Intelligence Community Campus-Bethesda (ICC-B) : South Campus Improvements; Submittal #2, Voluntary Submittal following MR2011105-MDP-4 for Façade Improvements to Roberdeau/Erskine Halls

January 16, 2014

Erskine Façade Facing Sangamore

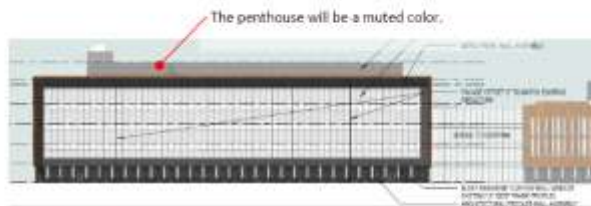
Originally, the new façade enveloped the entire existing penthouse with a "hood".

Aerial view of existing conditions showing the south façade and the expansion concept for the top floor.

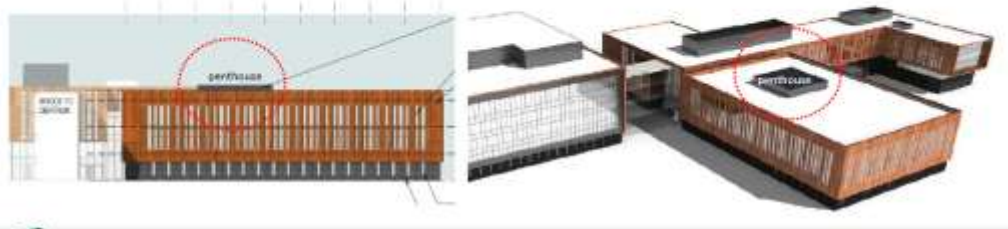
The top floor of the building will be expanded to the full size of the floor below.

Two existing cooling towers will be removed.

A new rooftop penthouse for mechanical equipment will be hard to see because it will be:

- a muted color
- set back from edges
- compact
